NUCLEAR REACTOR LABORATORY
MASSACHUSETTS INSTITUTE OF TECHNOLOGY

Subject: SAR Revision No. 20 and License No. R-37 Amendment Request,
Docket 50-20

SAR Revision No. 20

REACTOR FLOOR PLAN
FIGURE 3.2.3.2

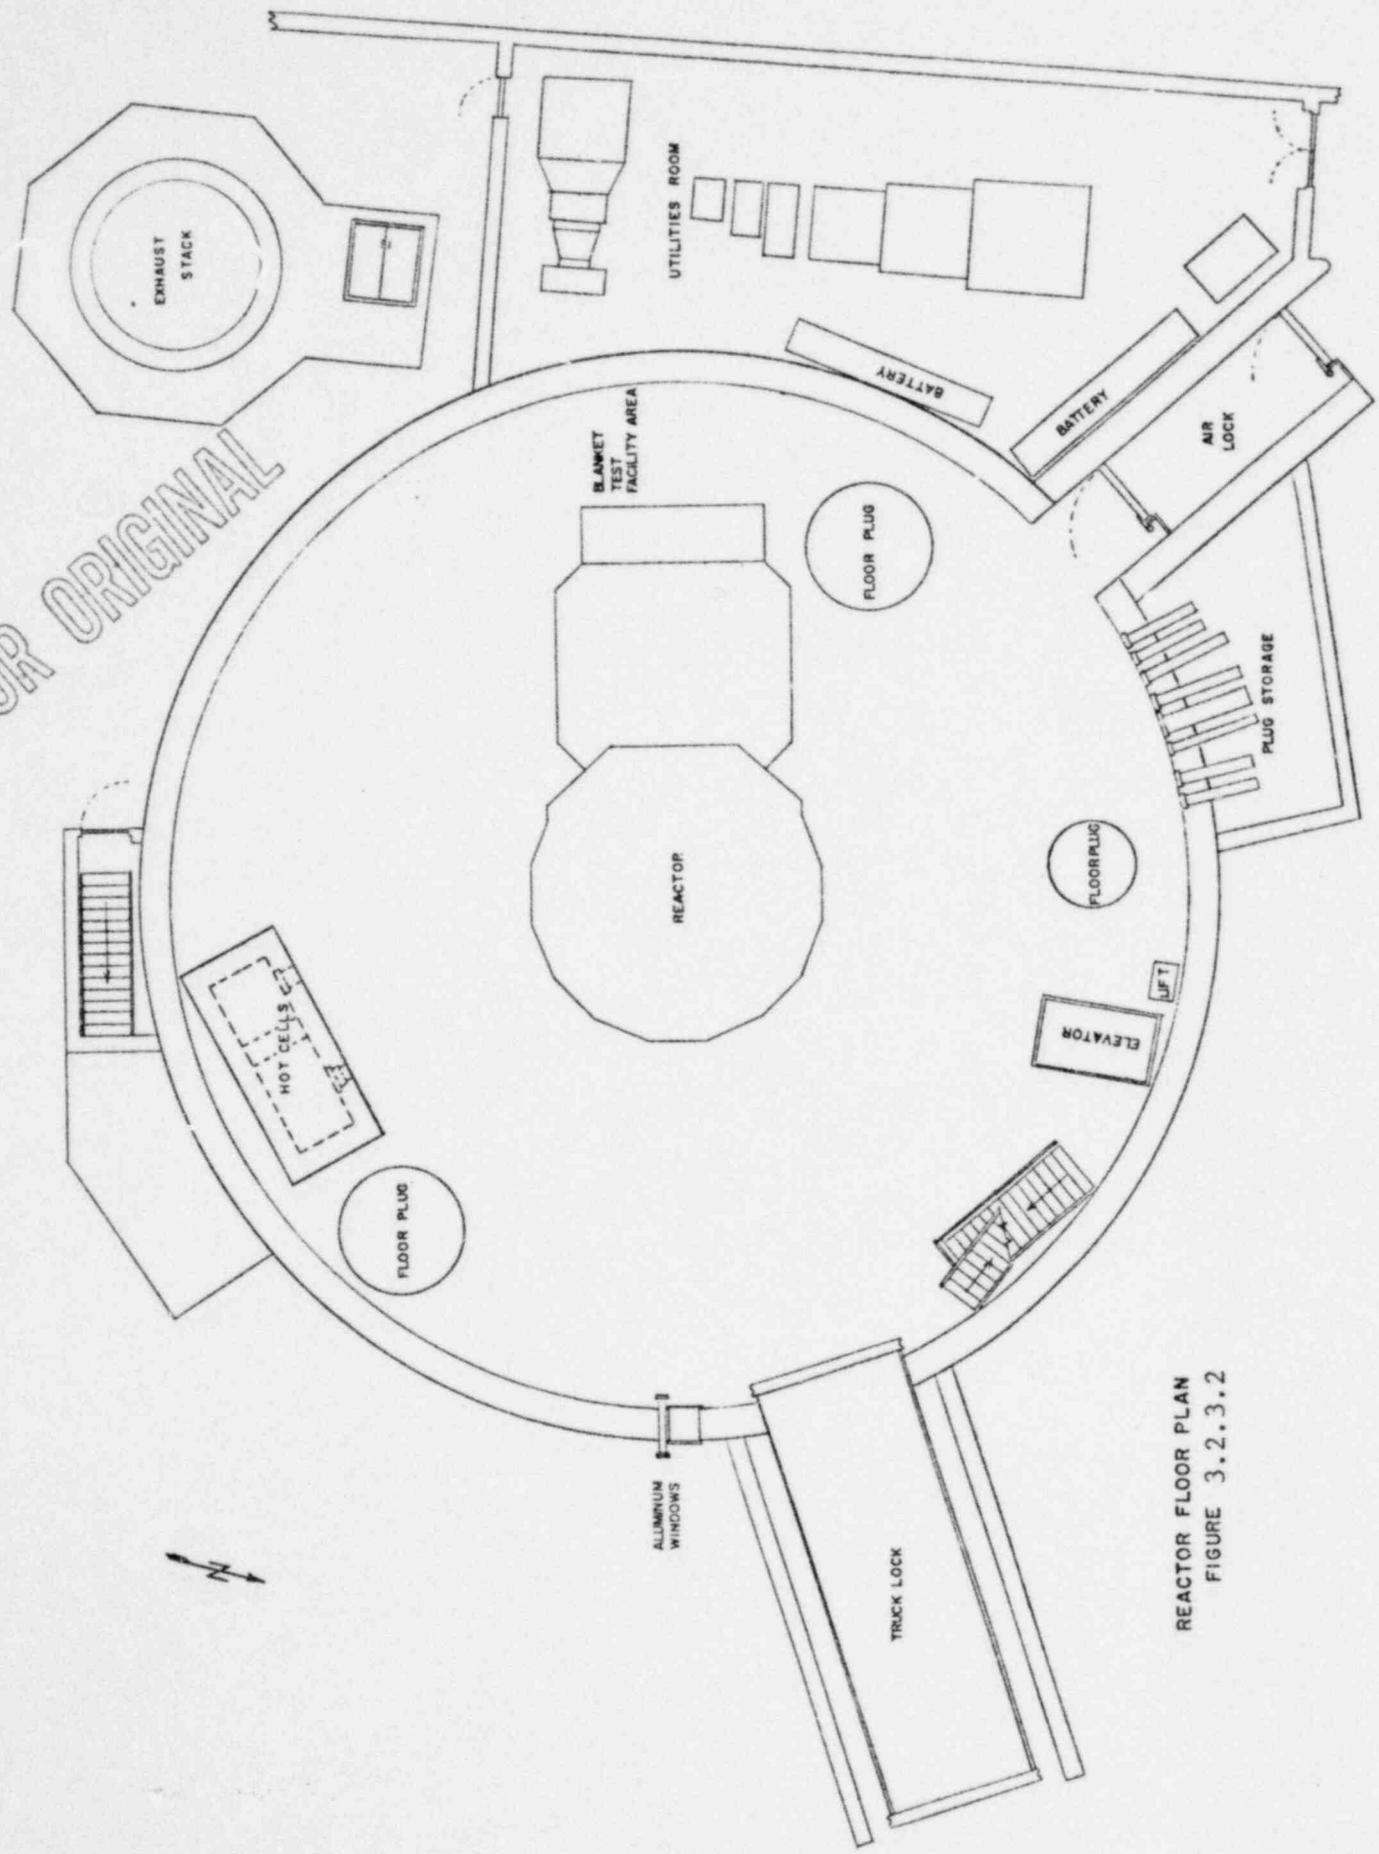
<u>Remove</u>	<u>Insert</u>	<u>Description of Revision</u>
3.2.3-6 (8/15/70)	3.2.3-6 (2/6/80)	Brief description of hot cells added to section 3.2.3, Reactor Building.
Fig. 3.2.3.2 (11/14/72)	Fig. 3.2.3.2 (2/6/80)	Updates reactor floor plan to show location of hot cells.
---	10.6a, b (2/6/80)	New section 10.1.5 providing a description of the hot cells and information on ventilation, instrumentation and fire prevention.
---	10.8a, b (2/6/80)	New section 10.4 providing criteria for hot cell experiments.
---	10.31a (2/6/80)	New section 10.3.5 providing information on the experimental programs for which the hot cells are used.

Two adjacent hot cells that are constructed of eighteen inch thick concrete slabs are located along the southeast wall of the first floor of the containment building. The two cells provide approximately forty square feet of floor space in which to study specimens that have been irradiated in the reactor. Access is through two roof ports that are normally closed with stepped concrete plugs. A master-slave manipulator is provided for each cell along with a high-density leaded glass viewing window. Each cell's shielding has been designed so that dose rates on the reactor floor will be maintained well within the limits as prescribed in 10 CFR 20.
